1. Type of Well Oil Well	8. Well Name and No.						
2. Name of Operator Devon Energy	:	NEBU 411A  9. API Well No.					
3a. Address 3b. Phone No. (include area code)					30-039-27702		
PO Box 6459, Farmington, NM	<del></del>	505-632-0244		10. Field and Pool, or Exploratory Area  Basin Dakota Fruitand Coo			
<ol> <li>Location of Well (Footage, Sec., 7 NW SE, Unit J, 1,775' FSL &amp; 2</li> </ol>		7 <b>W</b>		11. County or Parish, State			
				Rio Art	iba, NM

Attached you will find a revised and corrected C-102, Drilling Plan, Tops, Casing and Cement Design, and Directional Plan.

### WELL LOCATION AND ACREAGE DEDICATION PLAT

### DRILLING PLAN

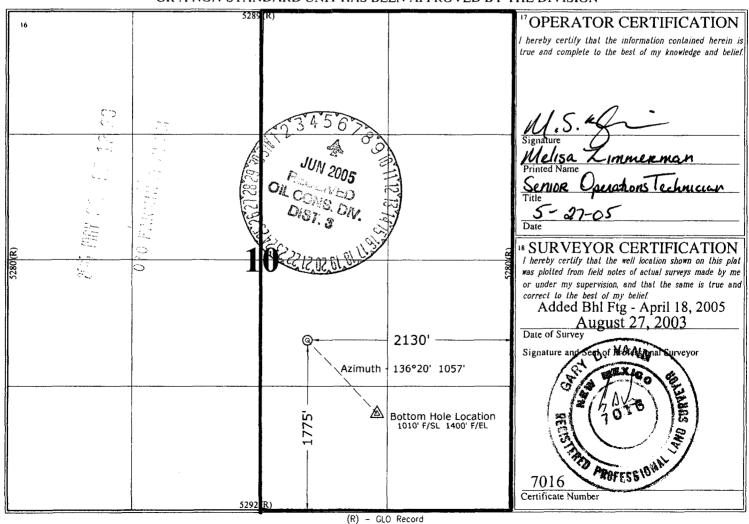
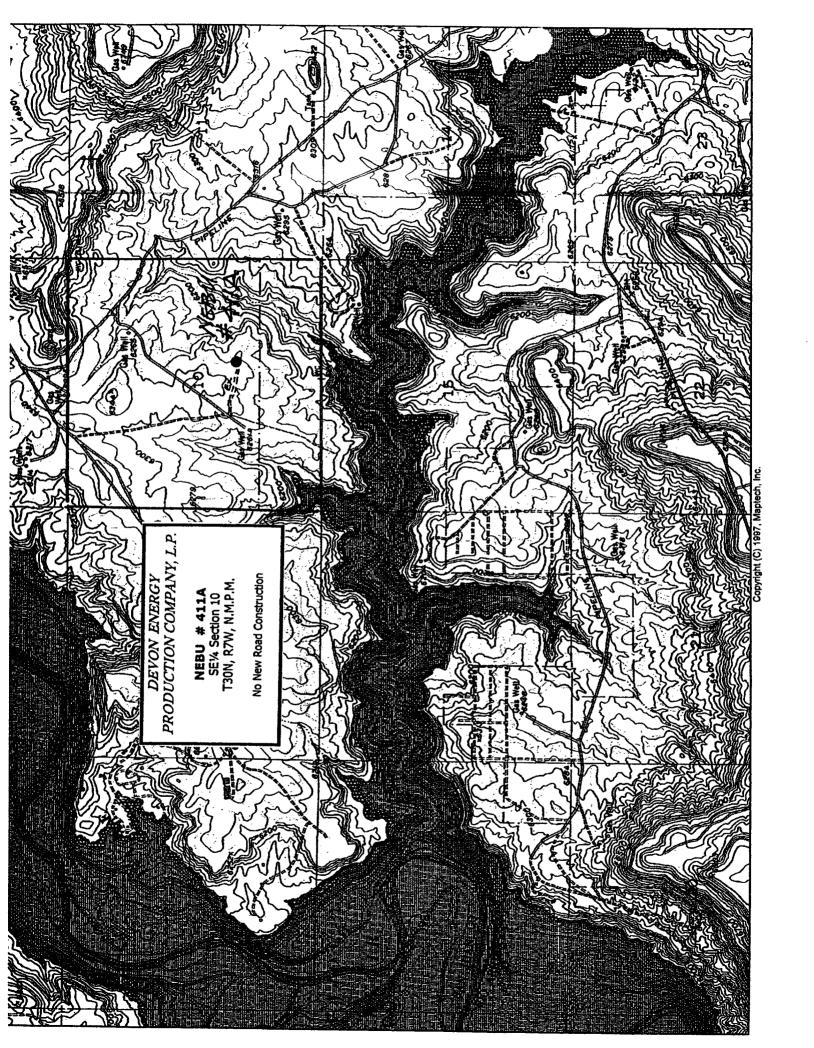
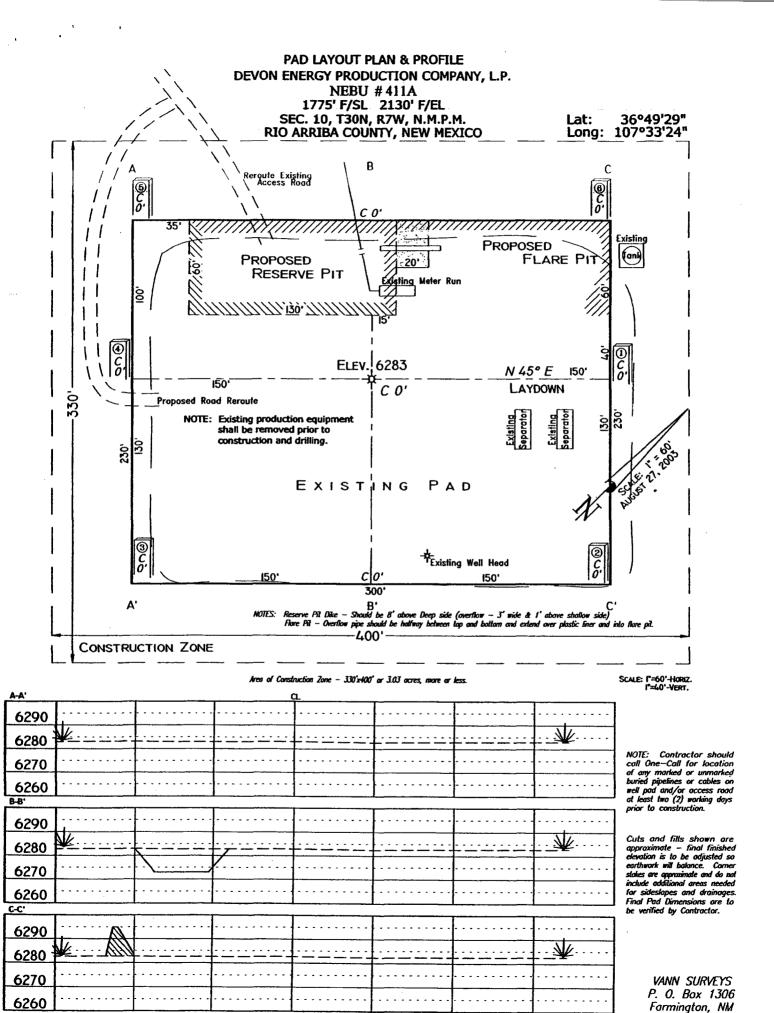
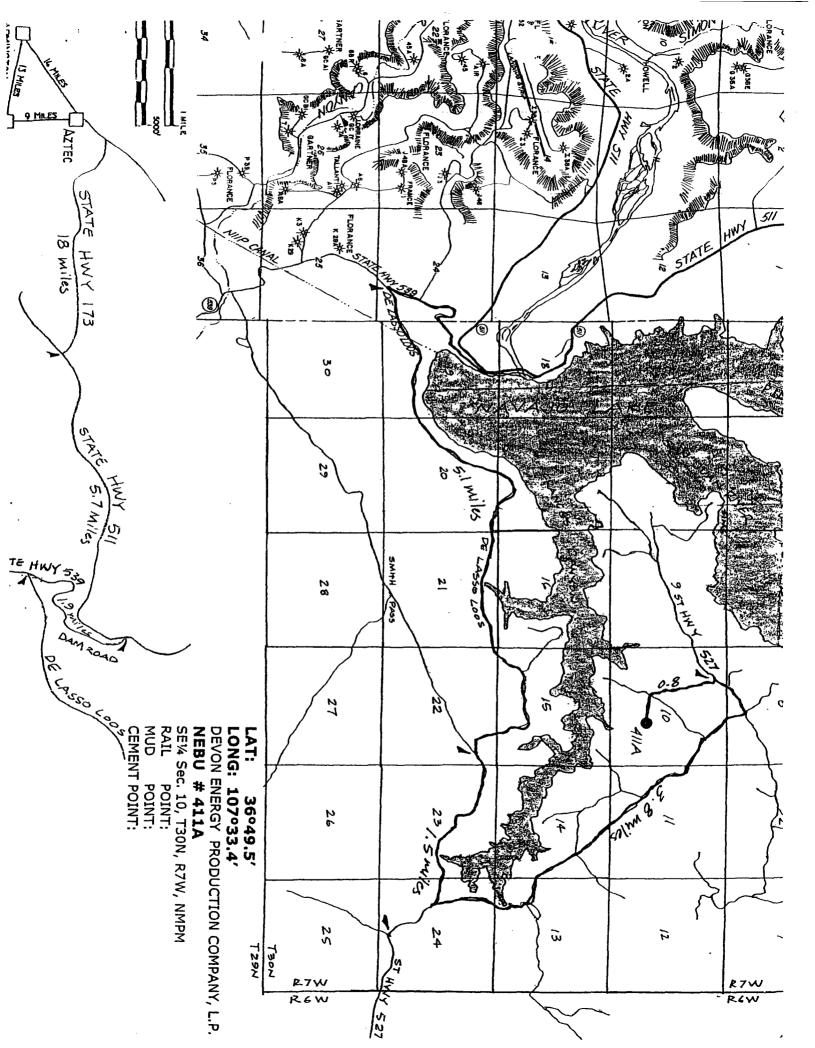
12. CHECK AP	PROPRIATE BOX(ES) TO	INDICATE NATUR	E OF NOTICE, RI	EPORT, OR	OTHER DATA		
TYPE OF SUBMISSION		TYI	PE OF ACTION				
Acidize Deepen Product Alter Casing Fracture Treat Recommendation Casing Repair New Construction Recommendation Change Plans Plug and Abandon Tempor Water				rt/Resume) andon	Water Shut-Off Well Integrity Other BHL Change

<sup>7</sup> UL or lot no.	Section	Township	Range	Lot Idn	Feet from the	North/South line	Feet from the	East/West line	County
O	10	30 N	7 W		1010	SOUTH	1400	EAST	Rio Arriba
12 Dedicated Acres	13 Joint	t or Infill	Consolidatio	n Code 15	Order No.		1	L
